**SERVICE BULLETIN**

**SB050-0999**

Subject: Lancair Main Gear Reinforcement (Lancair 200,235,320,360)  
Date: 5 September, 1999  
Ref: Construction manual, chapters 3 & 5 standard, chapter 2 fast build  
Pages: 2  
Status: Mandatory

Figure 1

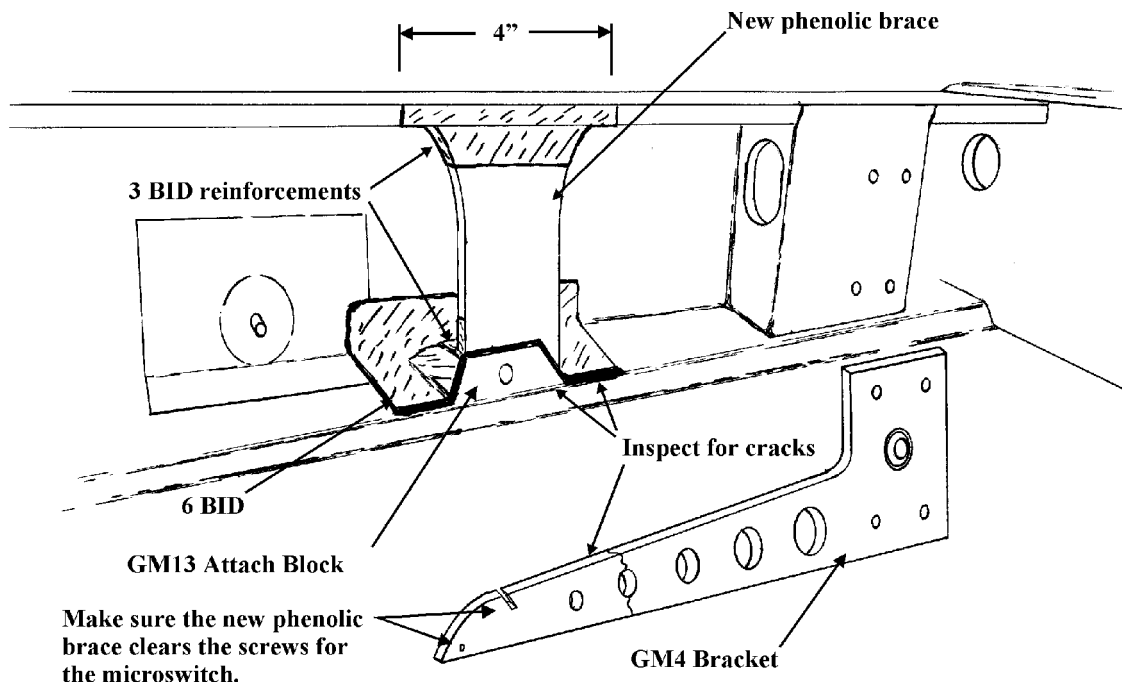
**Background:** On several occasions the secondary main gear attach block (GM13) has broken loose from the lower spar cap. On at least one occasion the 6 BID over the GM13 delaminated as well, transferring all side loads to the GM4 (GM004L & GM004-R) brackets. The GM4 bracket cracked from excessive strain and broke at the inboard lightening hole (later versions don't have the lightening hole) causing the gear to partially collapse.

5. Install a 1/4" thick phenolic brace with Hysol/flox. Make sure the screws for the microswitch will clear. Place a 3 BID at the top and bottom of the brace and let cure. See figure 1. Re-assemble the main gear.

6. If there is only delamination between the GM13 and the lower spar cap, apply a side load to the main gear leg and (after cleaning) push some Hysol/flox into the crack under the GM13 attach bracket. Release the side load and look for good squeezeout. Install the 1/4" phenolic brace (see figure 1). Re-assemble the main gear.

7. We consider the added ¼" phenolic brace as mandatory in all cases within the next 20 hours. Flight during this time period is acceptable provided close inspections are made after landing.

NOTE: Apply the lower 3 BID reinforcement to the backside of the support.
